Title of Document: Request for Change		Issue No. G20-03882	Rev. 0
Customer:		Issue date: June 15, 2020	
Title subject: ZRO connector 48-circuit Female assembly: Change the color tone of wire seal		Revision date:

48ZRO-B-2A

2A type
(Before change)

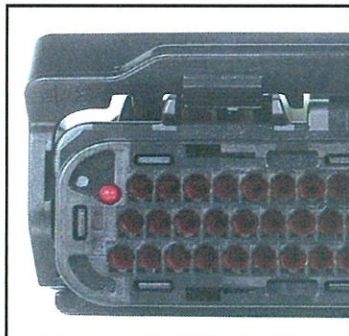
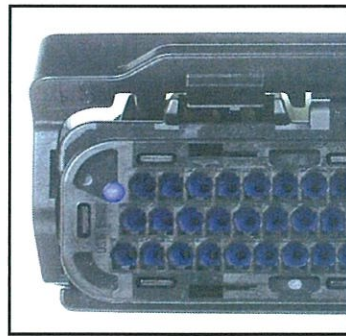
According to the review of production system for the aforementioned product, the wire seal of 2A type will be changed in color from red to blue.

Part Number	Wire seal color	
	Before change	After change
48ZRO-B-2A	Red	Blue

1A type

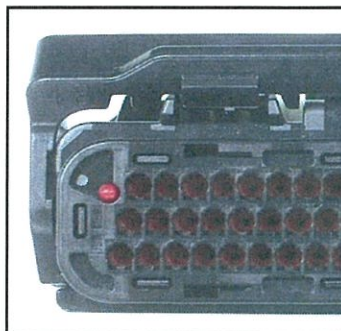
Since the color tone of wire seals used for 1A type and 2A type is similar, this change is carried out to identity easily.
